URBAN DESIGN COMMISSION APPLICATION CITY OF MADISON

1. Project Address: 1702 W. Bellline Hwy
Project Title (if any): Raise structure height and install digital sign faces

Subject: Permit request for advertising Sign Modification, 1702 W. Beltline HWY, Permit No: ZONGSN-2017-000315

PROPOSAL DRAWING

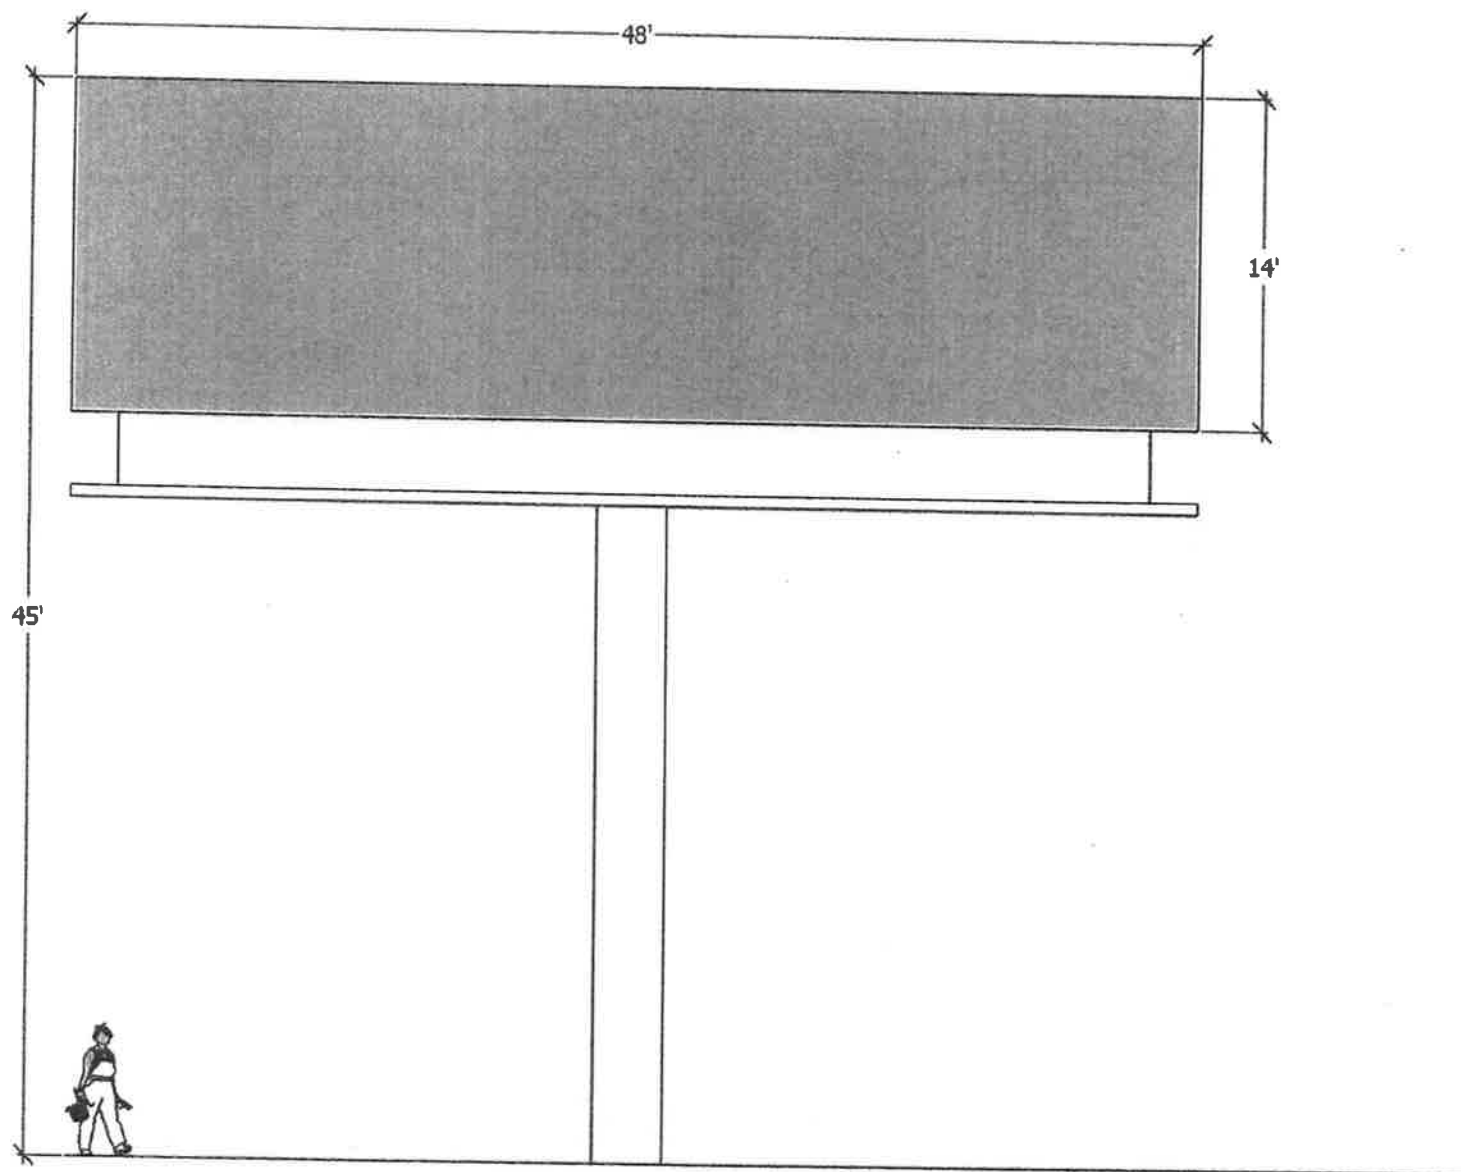
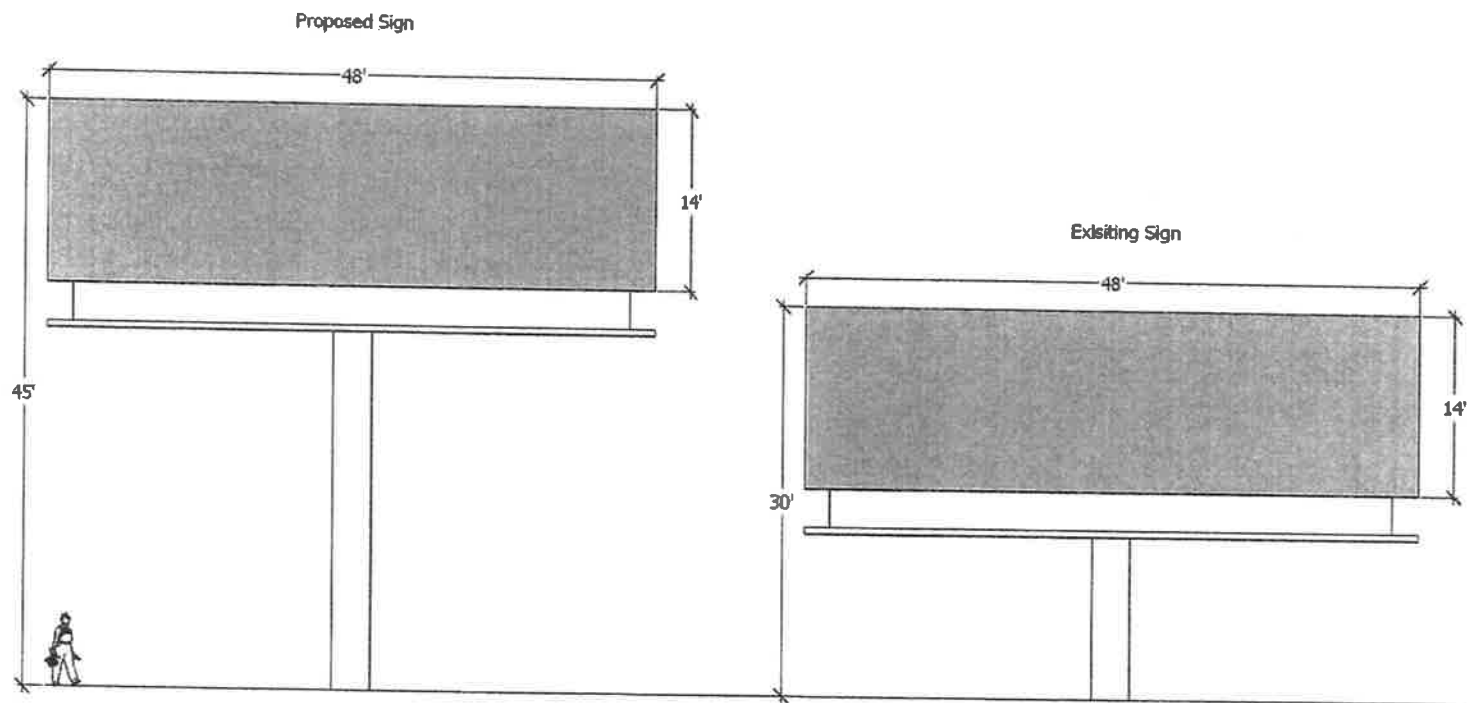
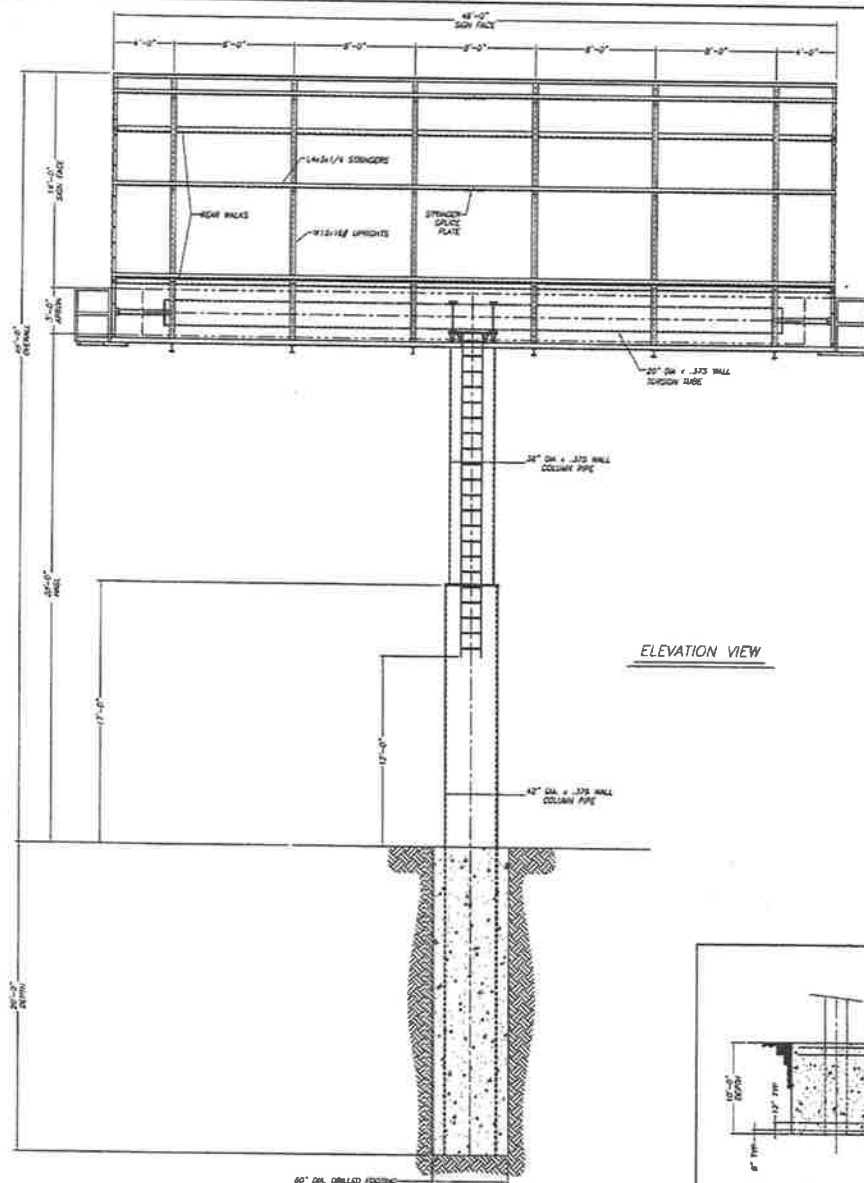
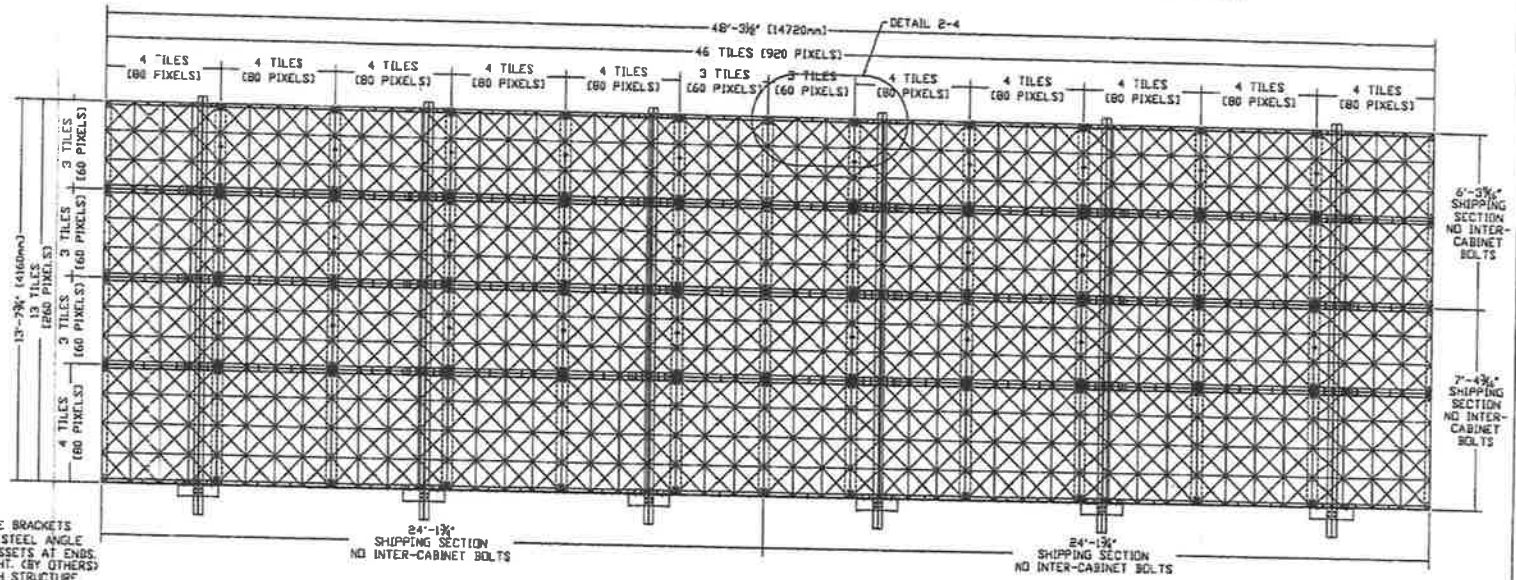
You have requested a permit to remove and reconstruct a new sign at a similar location to an existing advertising sign. The changes requested to the sign would increase the height of the sign and add "digital image" technology.

Your requested changes to this existing advertising sign would violate the provision of MGO 31.05(2)(b) by increasing the height and replacing the sign with a new sign and new digital image sign faces to accomplish the requested change(s).

1. The proposed sign exceeds height maximum per Sec. 31.11(2)(f),
2. The proposed sign includes digital image technology. Sec. 31.045(3)(i) prohibits "digital

image" signs.

The proposed sign / sign changes are not in compliance with MGO Chapter 31. Your permit request is hereby denied. Any appeal of this decision may be made to the Urban Design Commission within thirty (30) days, under sec. 31.043(1), Zoning Administrator Appeals.
